Notice of Intent

Sundry ID: 2839941

Type of Action: APD Change

XTO respectfully requests approval to make the below listed changes to the approved APDs.

**Previous Design: 4-String Design – Engineered Weak Point****[Figure F] 4 String – 2<sup>nd</sup> Intermediate casing engineered weak point**

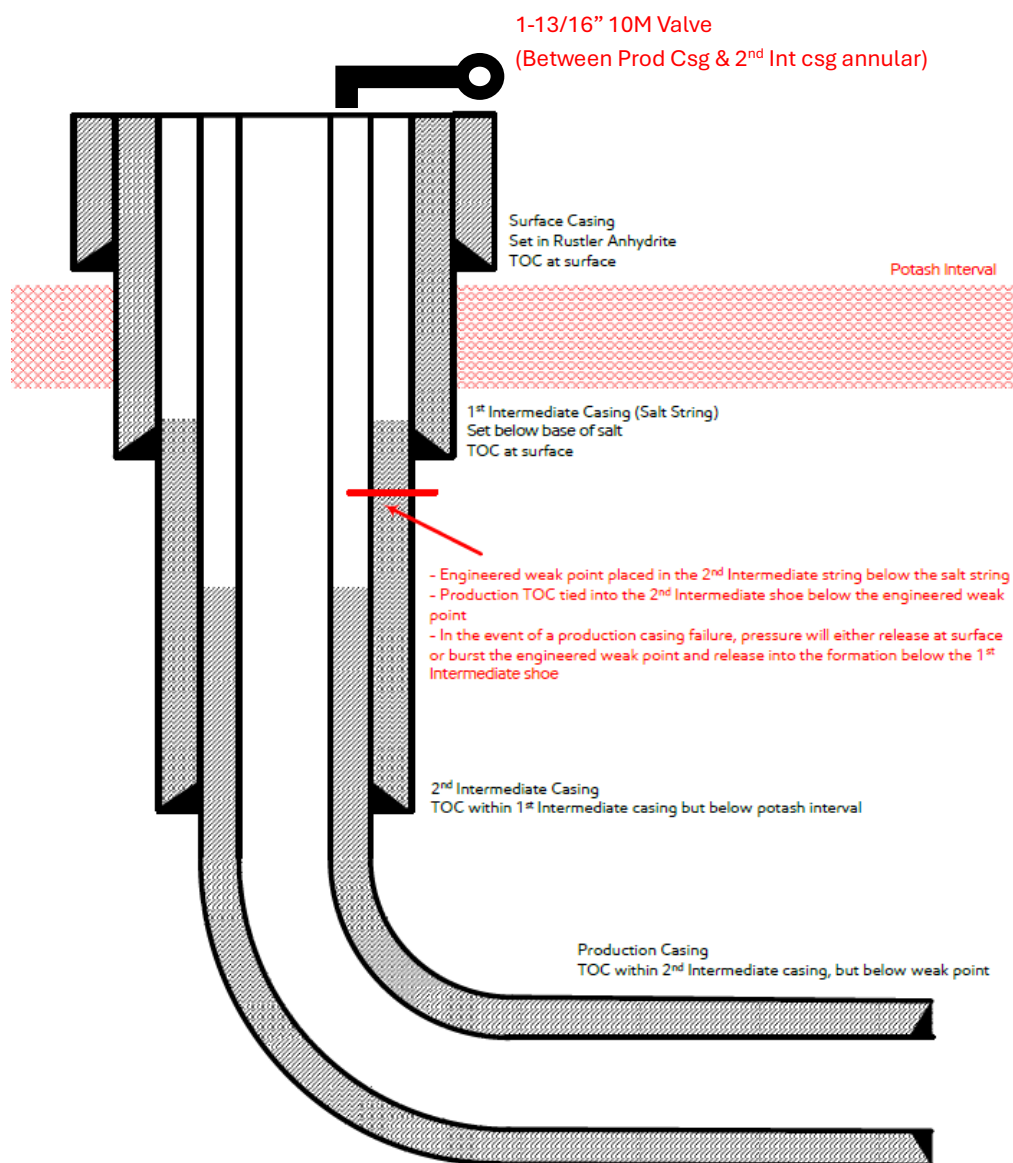
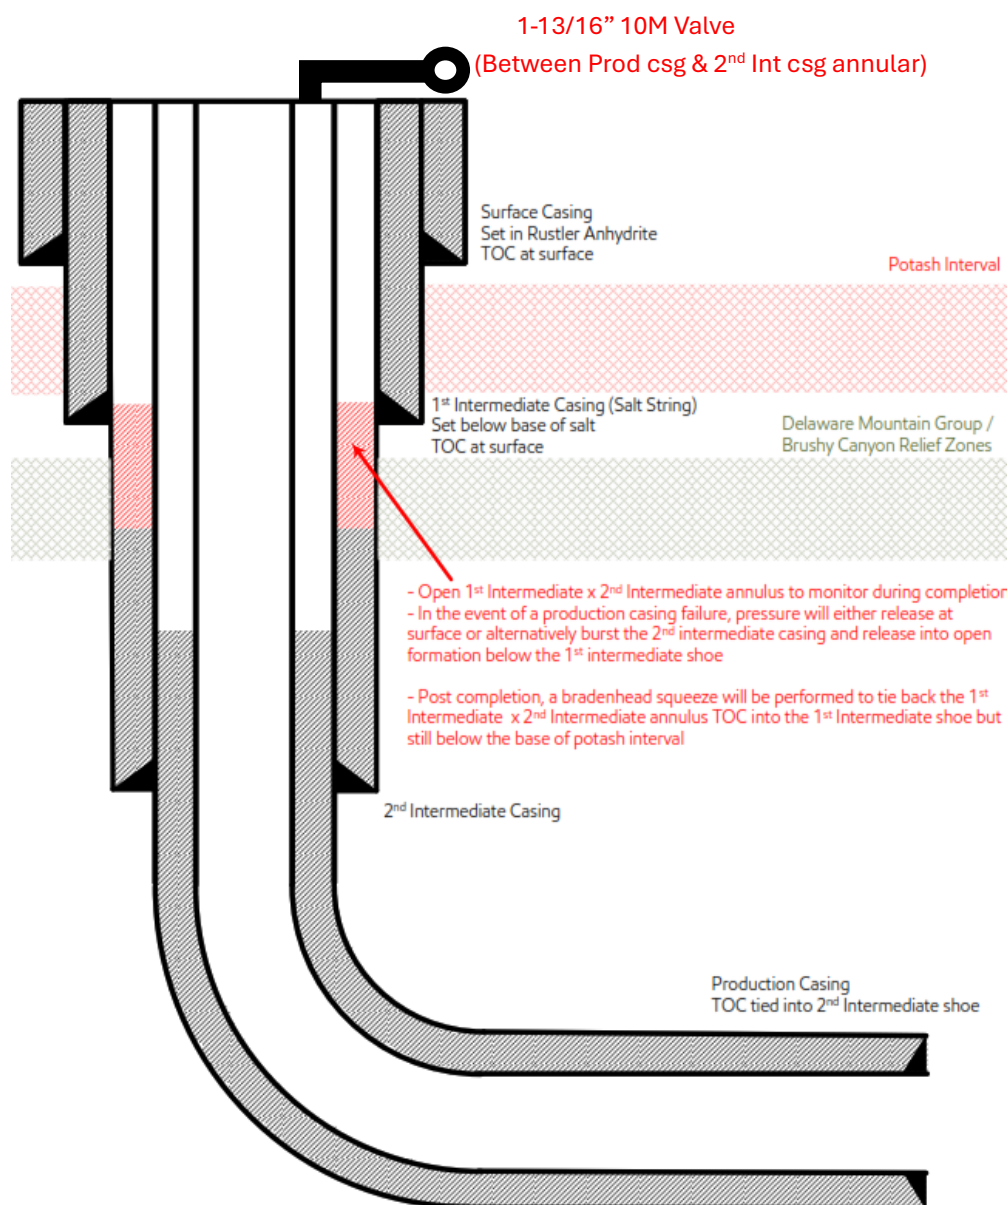
1. Casing design to be changed from the "4-String Design – Engineered Weak Point" (FIGURE F) to the "4-String Design – Open 1<sup>st</sup> INT x 2<sup>nd</sup> INT Annulus" (FIGURE D). An open annulus will be utilized and monitored during completions operations.

Post completion, bradenhead squeeze will be performed to tie back the 1<sup>st</sup> intermediate x 2<sup>nd</sup> intermediate annulus. TOC will be placed into the 1<sup>st</sup> intermediate shoe but still below the base of Potash interval.

2. No changes to the cementing, casing or mud circulating system designs will be required for the requested change.

**New Proposed Design: 4 – String Design – Open 1<sup>st</sup> Int X 2<sup>nd</sup> Int Annulus (ICP 2 below relief zone)****[Figure D] 4 String – Uncemented annulus between 1st and 2nd intermediate casing strings**

- 1) Alignment with KPLA requirements per schematic above, leaving open annulus open for pressure monitoring during frac and utilizing new casing that meets API standards.
- 2) Contingency plans in place to divert fluids away from salt interval in event of production casing failure.
- 3) **Intermediate 2 primary cement** job with TOC within Delaware Mountain Group with 0% excess & below the minimum 500' from intermediate 1 casing shoe
  - o **Intermediate 2 bradenhead squeeze** to be completed within 180 days after completions to tieback TOC to salt string at least 500ft but with top below Marker Bed 126.
- 4) Production cement to be tied back no less than 500ft inside previous casing shoe.
